**STAFF REPORT**

**CASE NUMBER:** P. D. 09-313 CC                      **L.U.C.B. MEETING:** July 9, 2009  
*Held from June 11, 2009*

**DEVELOPMENT:** WOODLAND HILLS PLANNED DEVELOPMENT, 10<sup>TH</sup> Amendment

**REQUEST:** Plan amendment to Parcel 5 to allow limited Planned Commercial(C-P) land uses.

**OUTLINE/CONCEPT PLAN:**

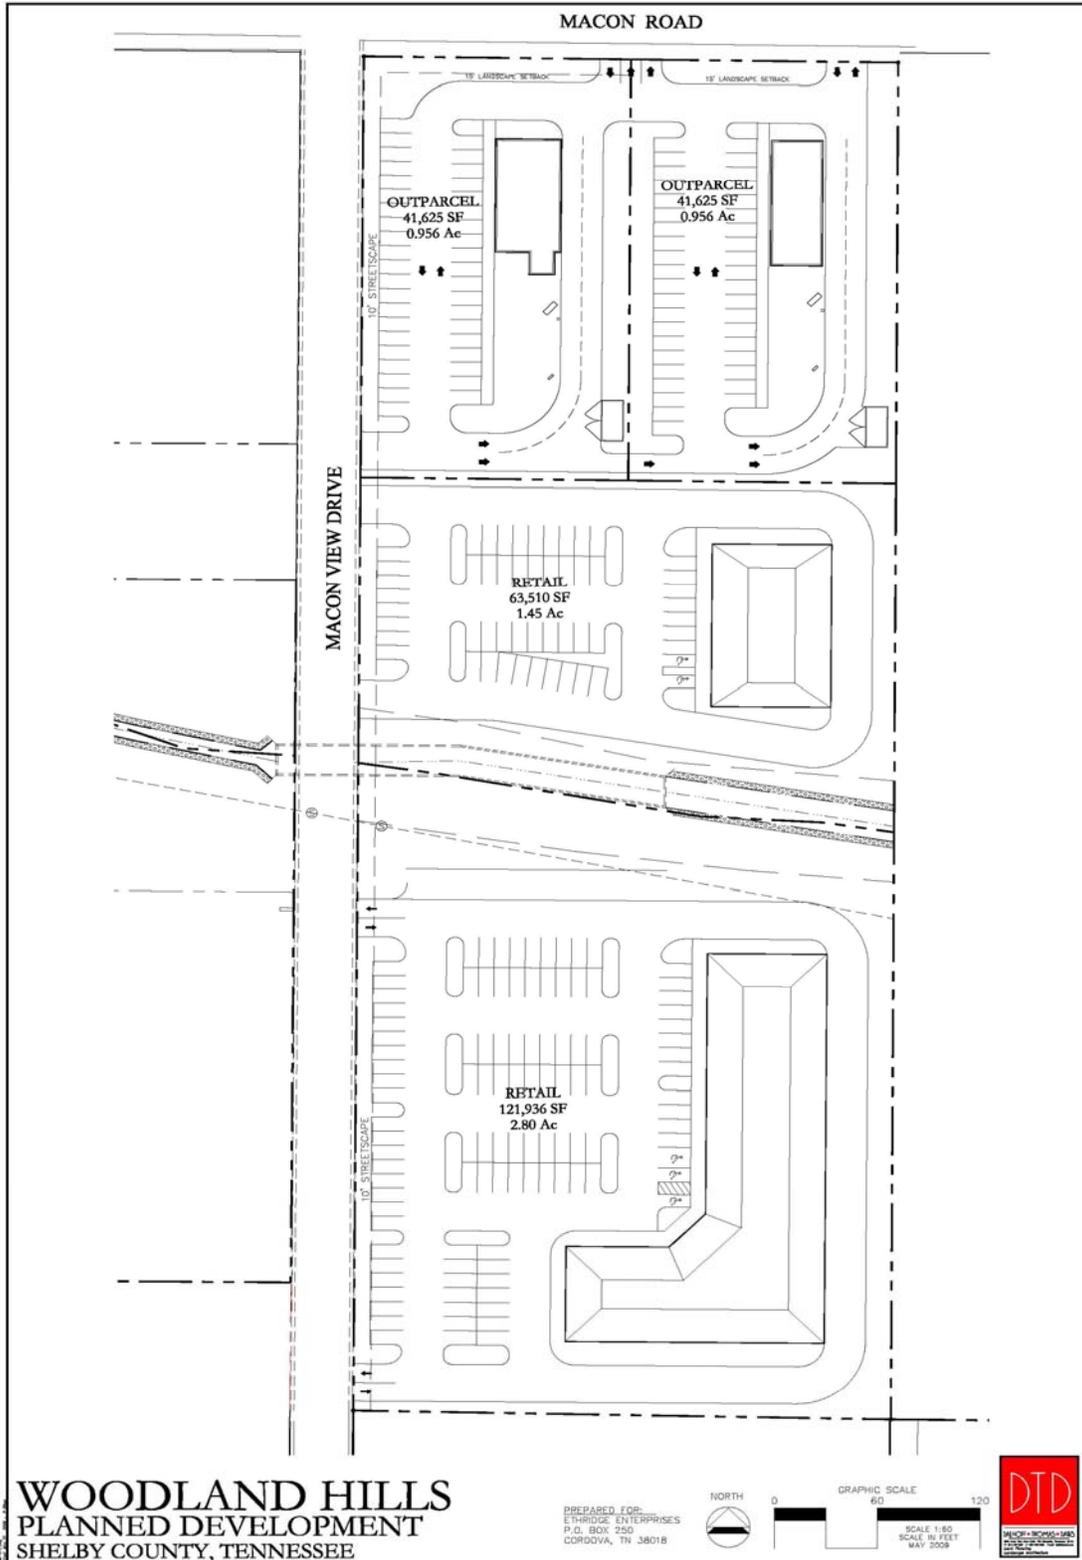
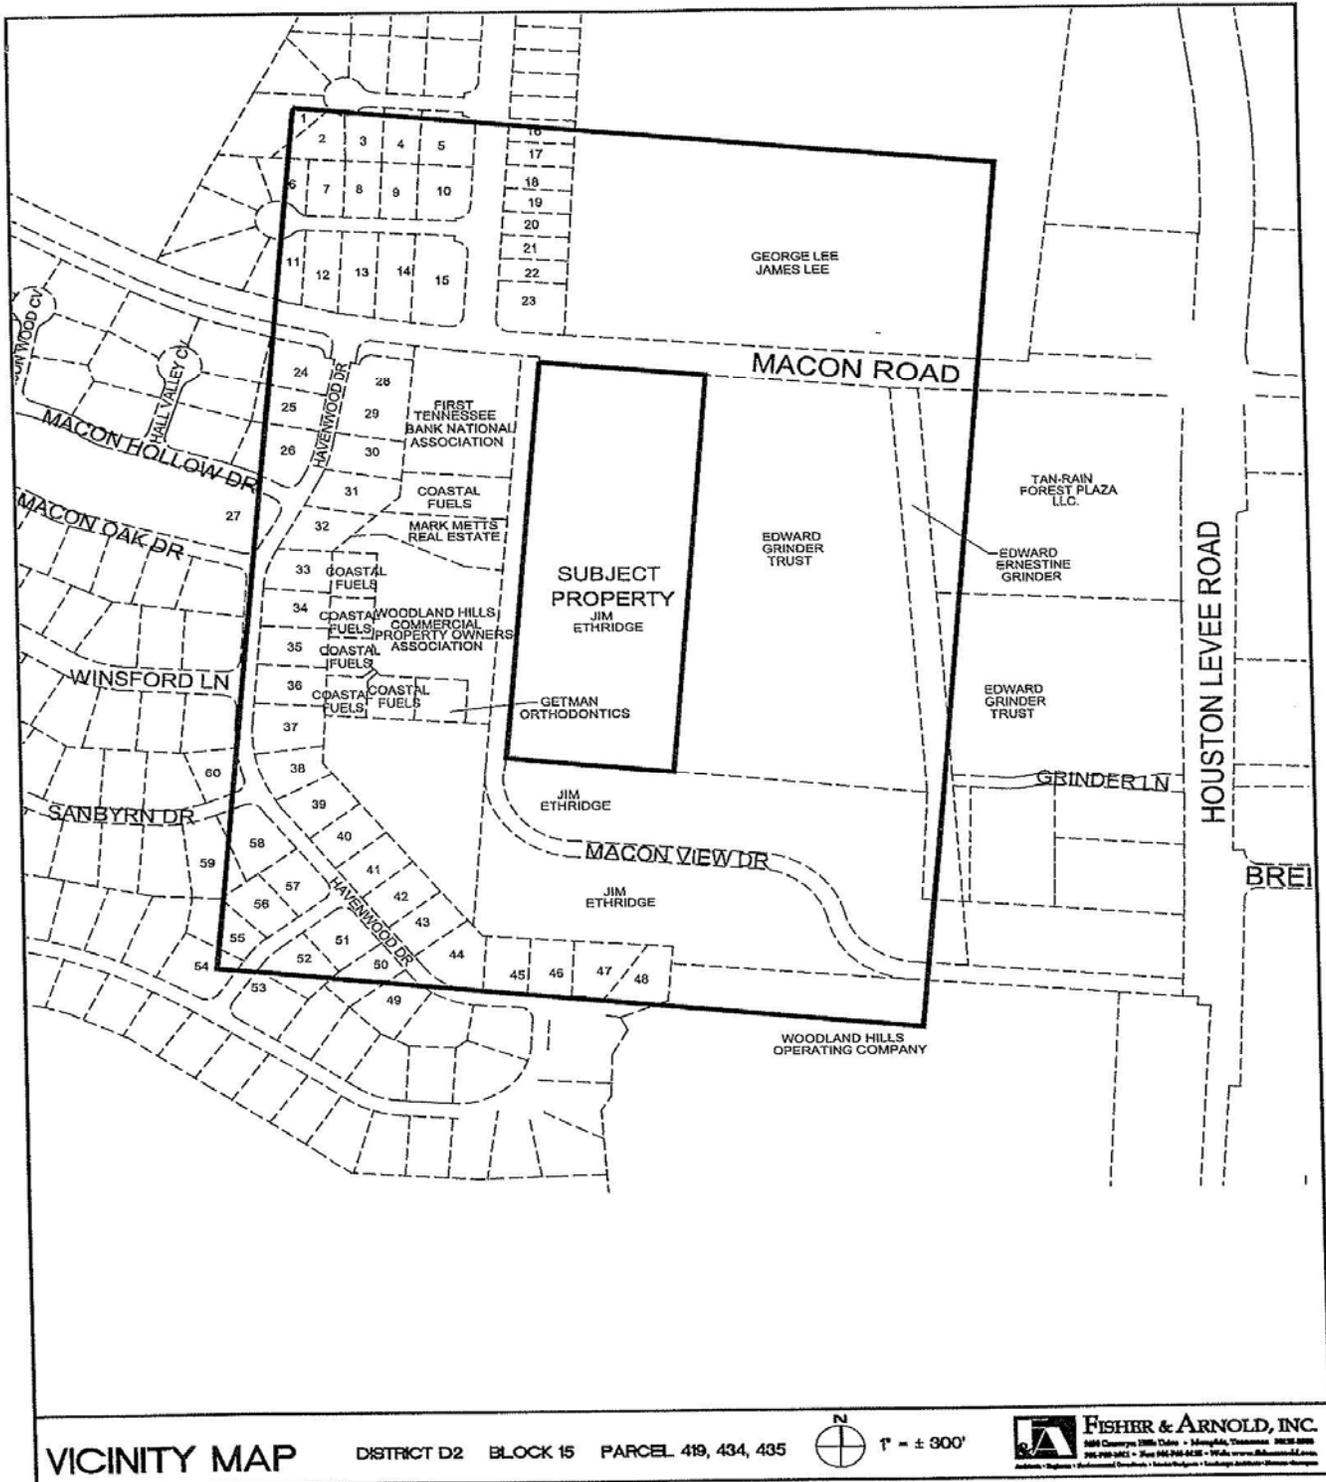
- 1. The requested amendment to Parcel 5 of the Outline Plan is to allow limited Planned Commercial(C-P) District land uses on a parcel specifically approved for one(1) restaurant building and professional offices.**

- 2. This Concept Plan illustrates the creation of two(2) of the four(4) commercial lots on a private drive, because it only has approximately 312.46 linear feet of public road frontage along Macon Road.**

- 3. The professional office land use approved in the original plan creates and maintains an office buffer similar to the relationship on the opposite corner. This transitional buffer between single family residential and commercial should be maintained and not compromise the existing conditions between the bank building and the single family homes—north and east of the subject property.**

- 4. Within the Gray's Creek Area, staff has continued to promote interconnectivity with a network of public streets to be dedicated and improved with curb, gutter and sidewalk. This amendment should seek to maintain consistency in concept planning of the area with existing and proposed development patterns conforming to planning and development standards.**

- 5. The existing office land use at the west side of the private drive creates a transitional use between single family residential and proposed retail development, However, allowing two(2) restaurant buildings without the benefit of a transitional office buffer cannot be supported for this plan amendment.**
